**Re: Minor Project Refinement No. 11 for the South Orange County Reliability Enhancement Project.**

**ATTACHMENT A**  
**MPR-11 Form**

## South Orange County Reliability Enhancement Project CPUC Minor Project Refinement Form

**ATTACHMENT B**  
**MPR-11 Figure**

View of MPR-11 Calle Lorenzo work area, facing north from the corner of Calle Lorenzo and Camino Capistrano, facing N.

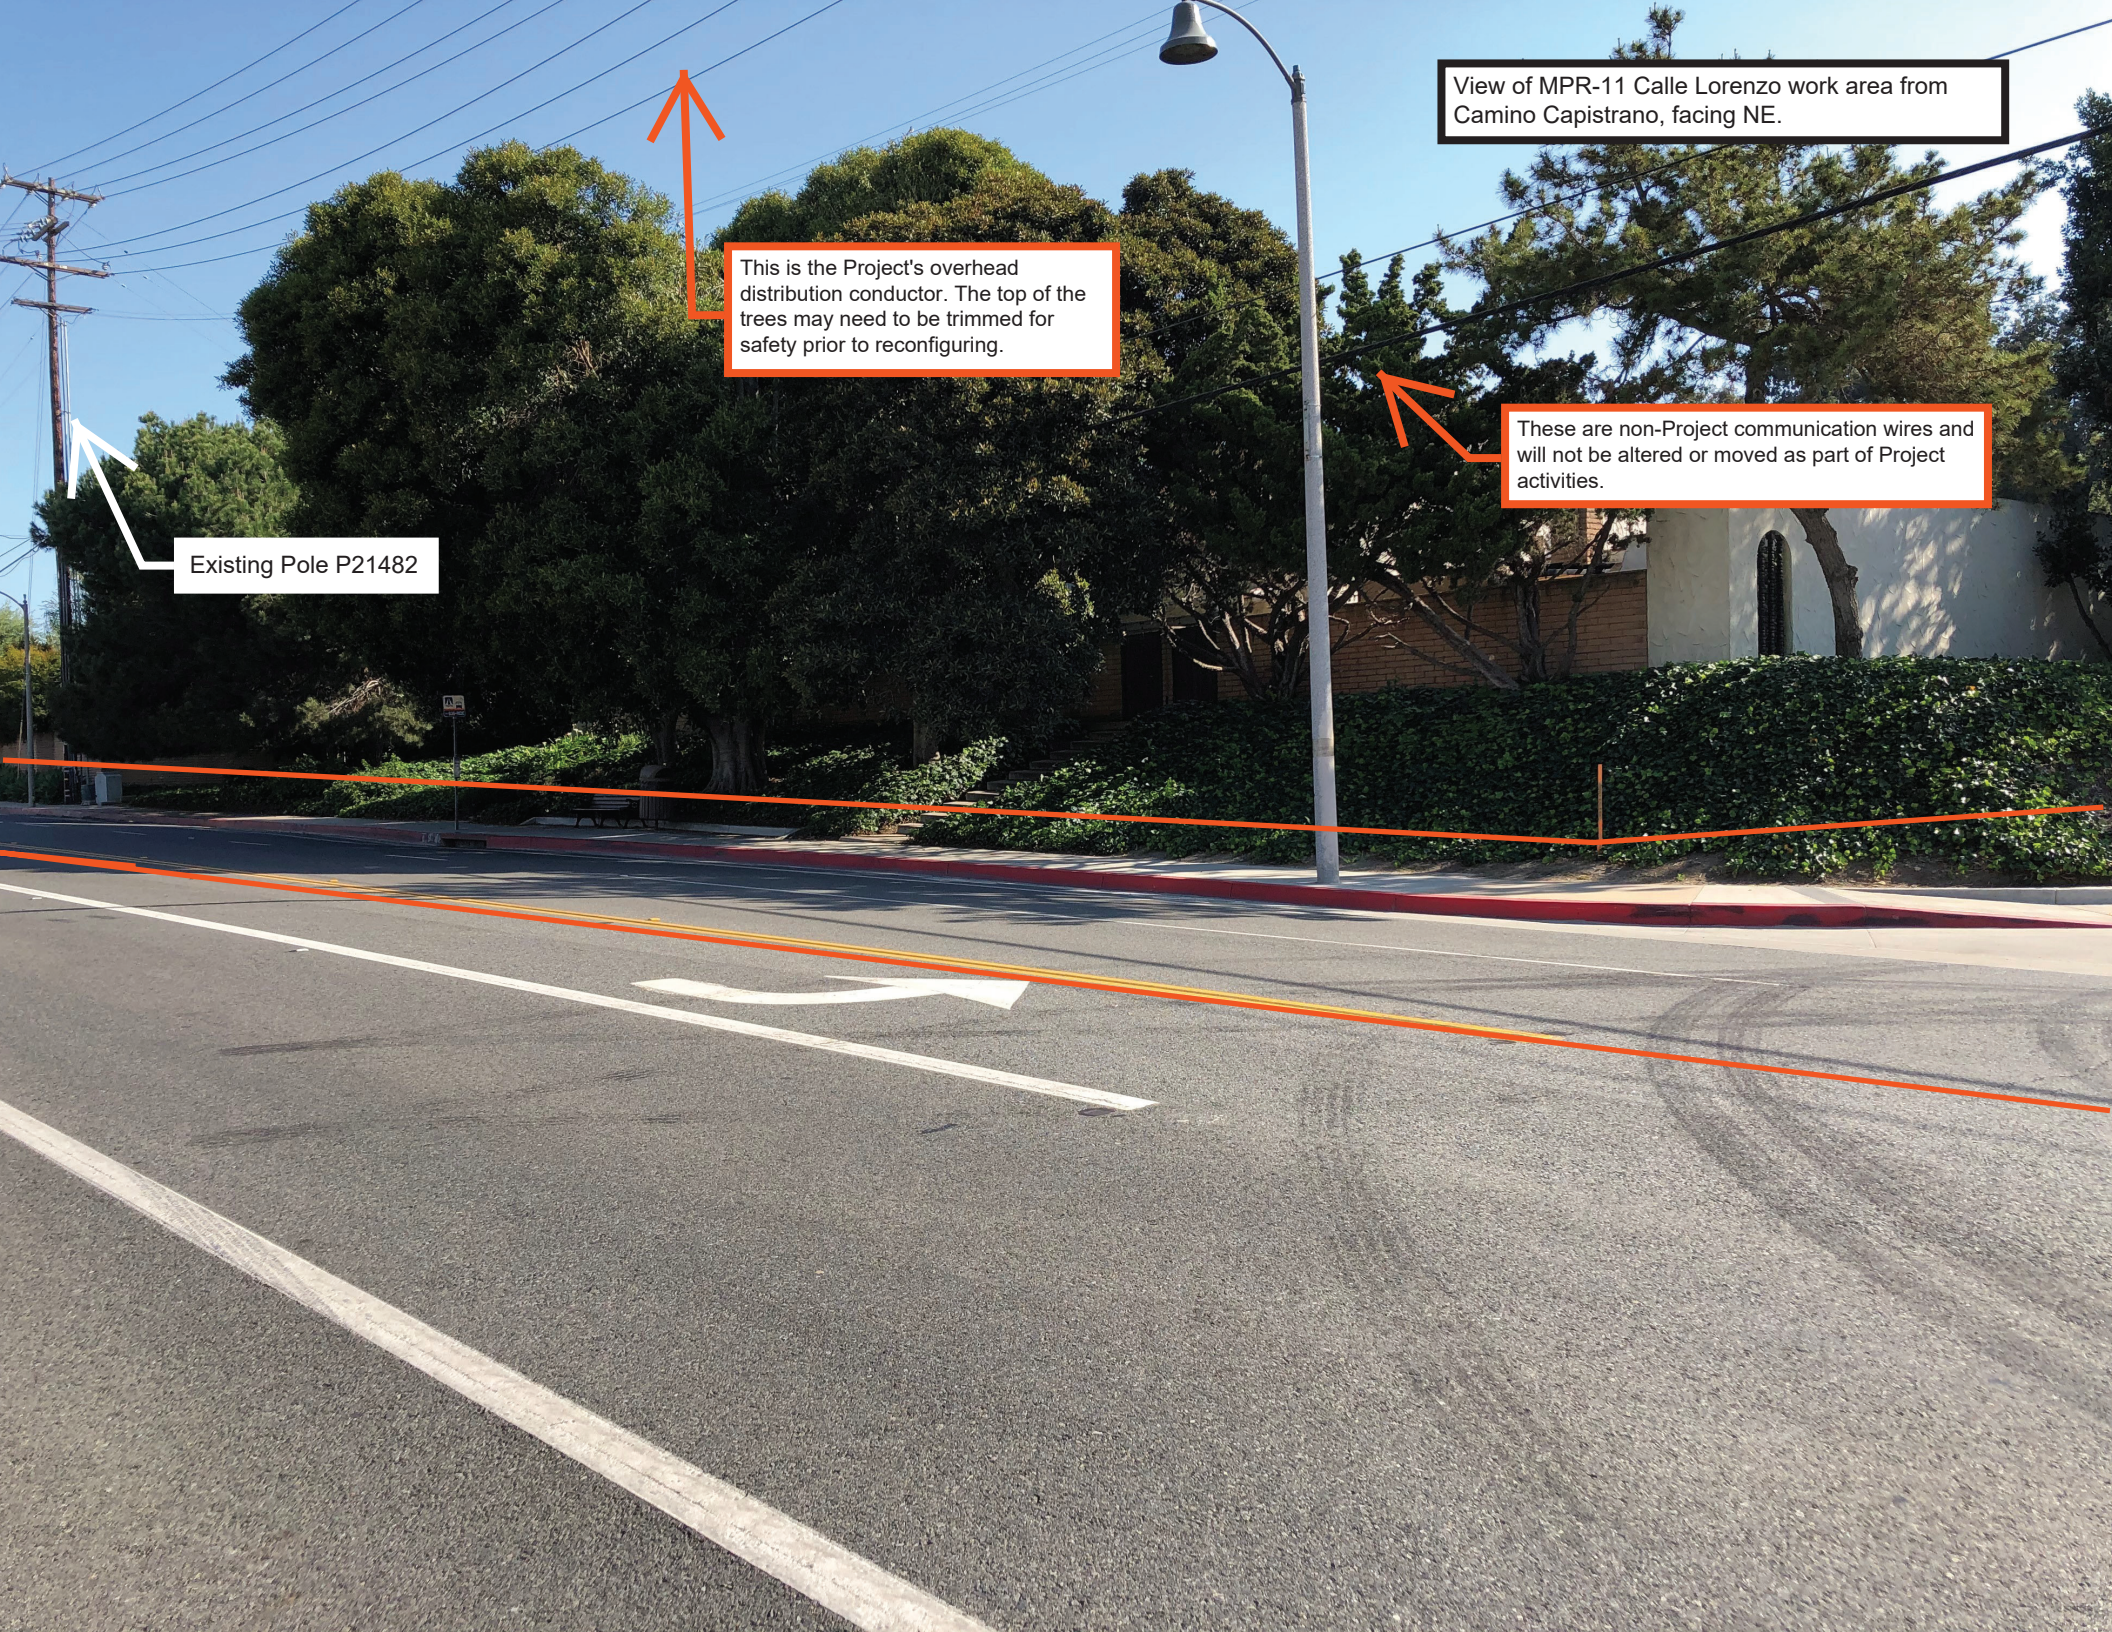
View of MPR-11 work area on corner of Calle Lorenzo and Camino Capistrano (shown in orange), adjacent to NTP-4 work area (shown in red). Approximate locations of the fuse box and underground conduit location shown in blue, facing S.

Existing pole P21481

Acacia cyclops, will possibly need to be removed.

Location of new pole D1
